| TYPE | YEAR | PROJECT NO. | SHEET NO. |
|---|---|---|---|
| R.O.W. | 2015 | HSIP-106(33) | 25 |
| CONST. | 2017 | HSIP-106(33) | 35 |

S.R. 106 WILLIAMSON CO.

BEGIN STA. 118+00.00
END STA. 119+00.00

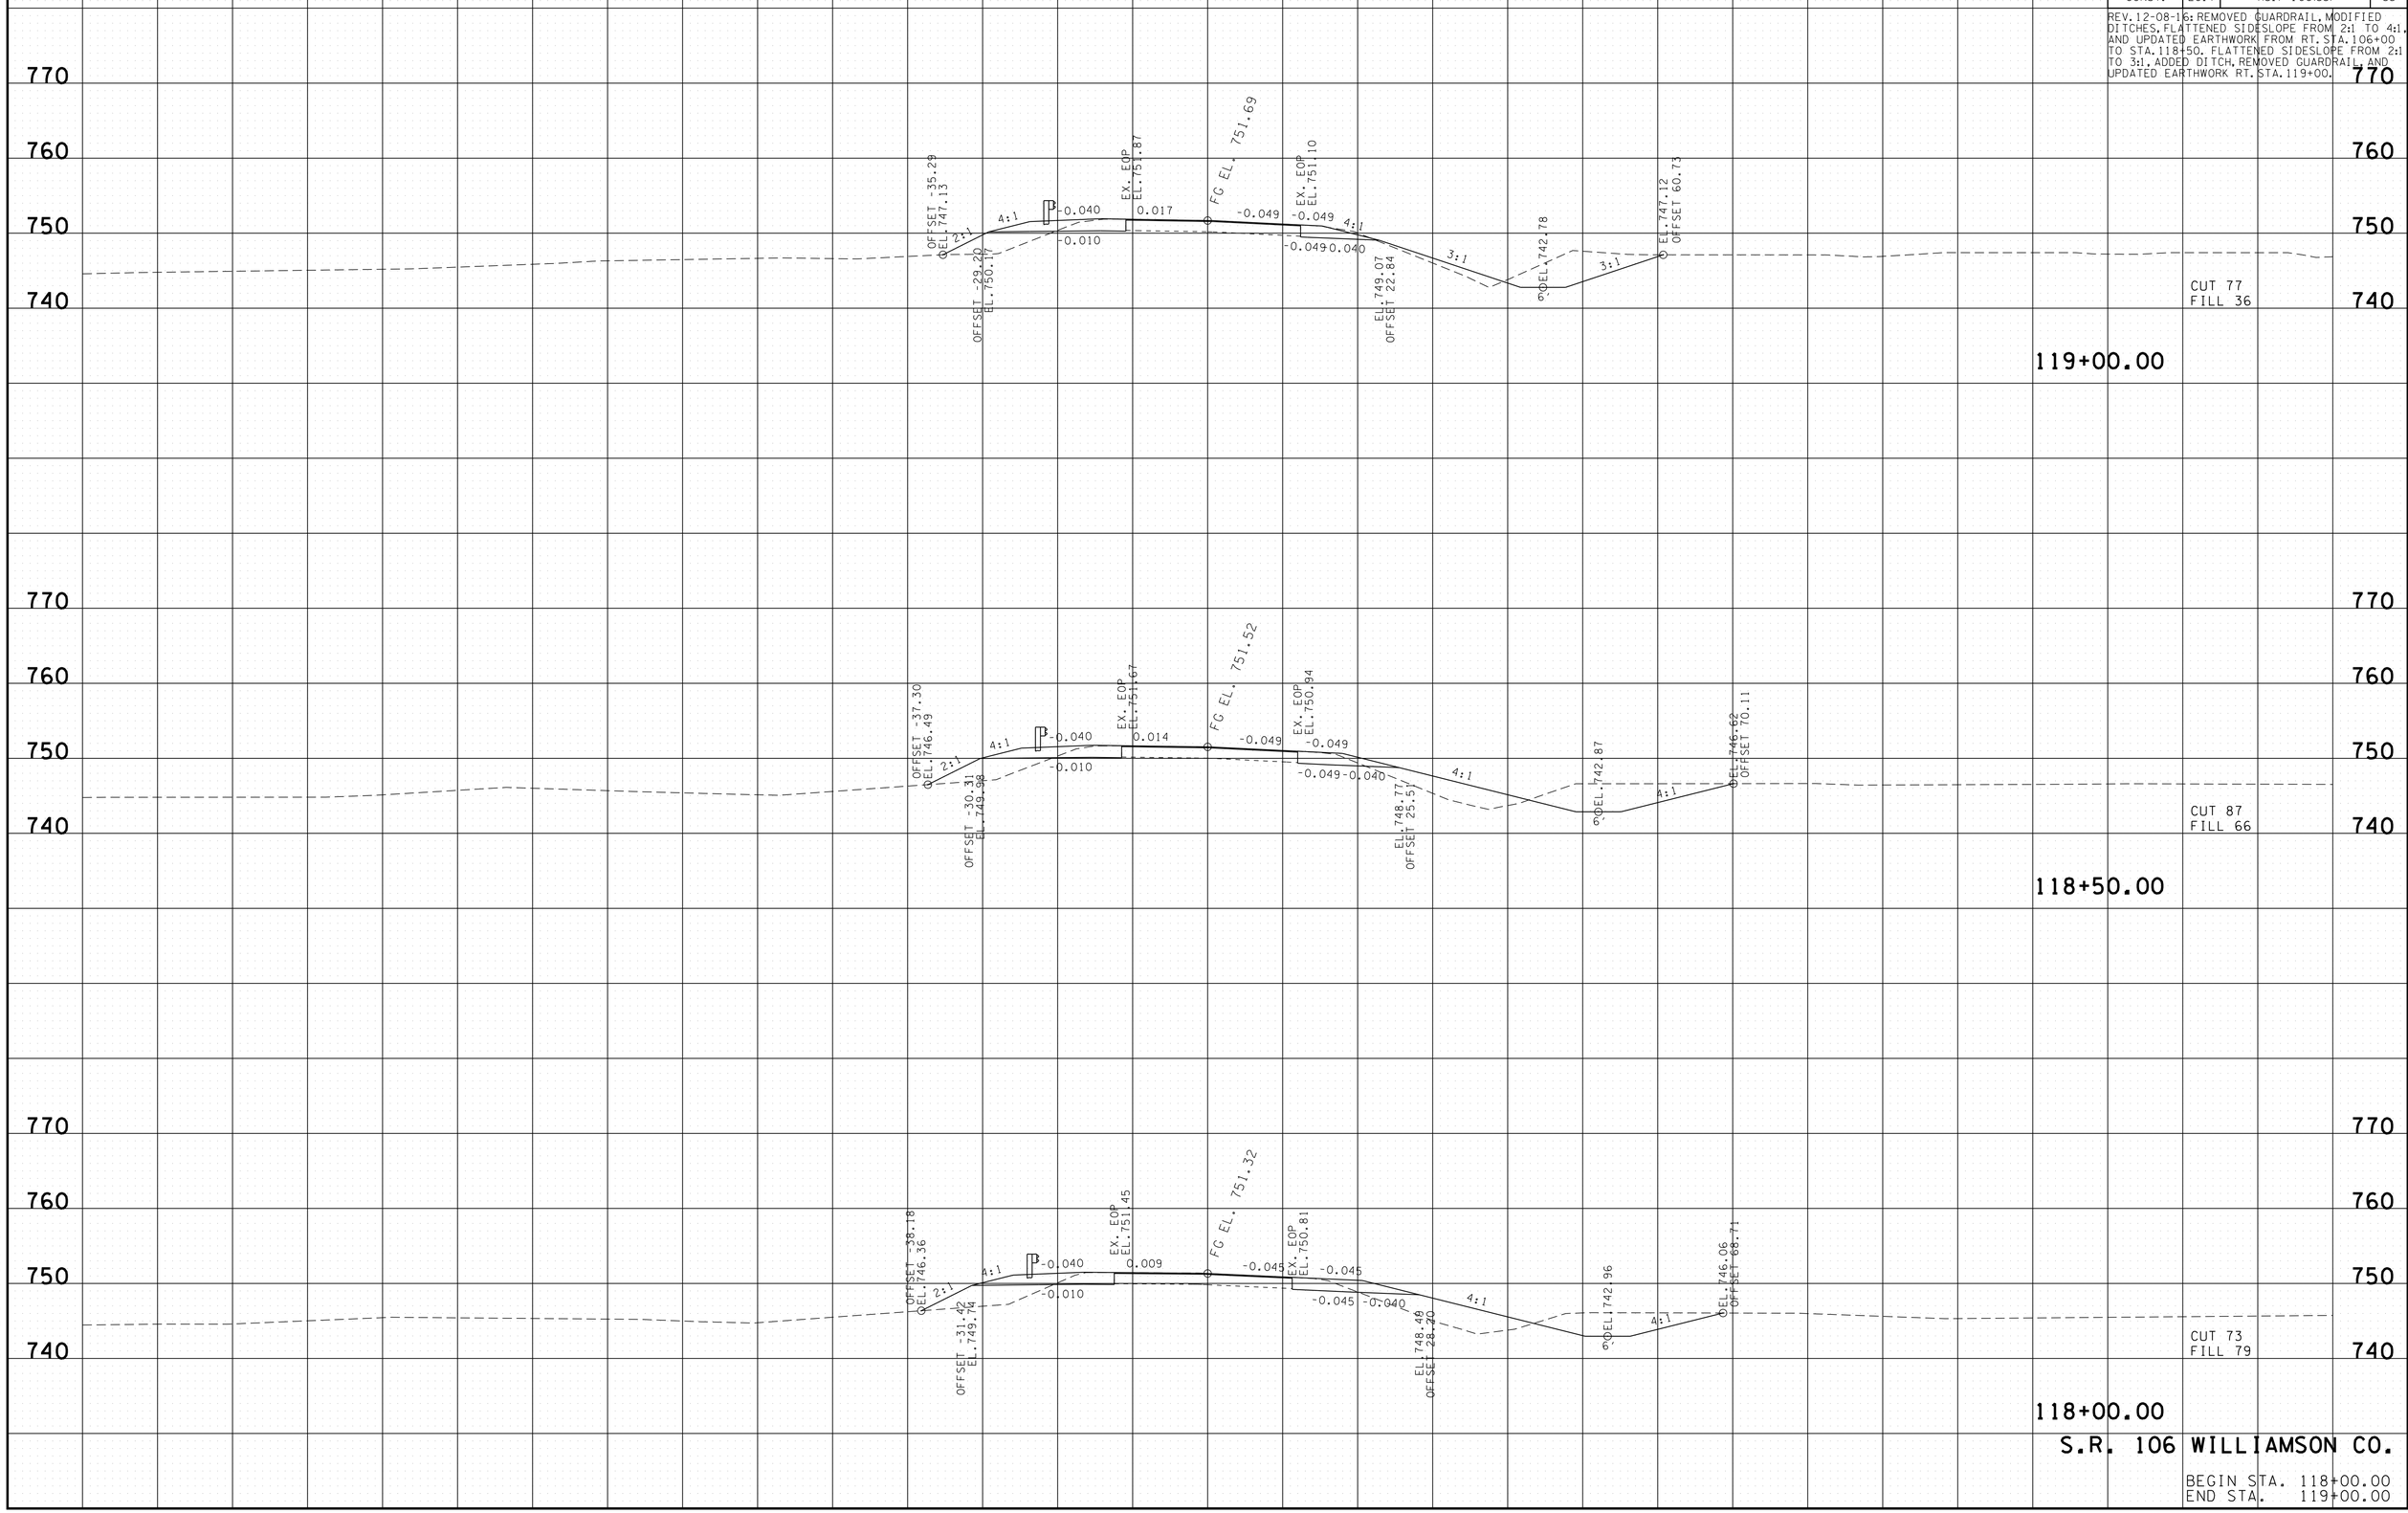
REV. 12-08-16: REMOVED GUARDRAIL, MODIFIED DITCHES, FLATTENED SIDESLOPE FROM 2:1 TO 4:1, AND UPDATED EARTHWORK FROM RT. STA. 106+00 TO STA. 118+50. FLATTENED SIDESLOPE FROM 2:1 TO 3:1, ADDED DITCH, REMOVED GUARDRAIL, AND UPDATED EARTHWORK RT. STA. 119+00.
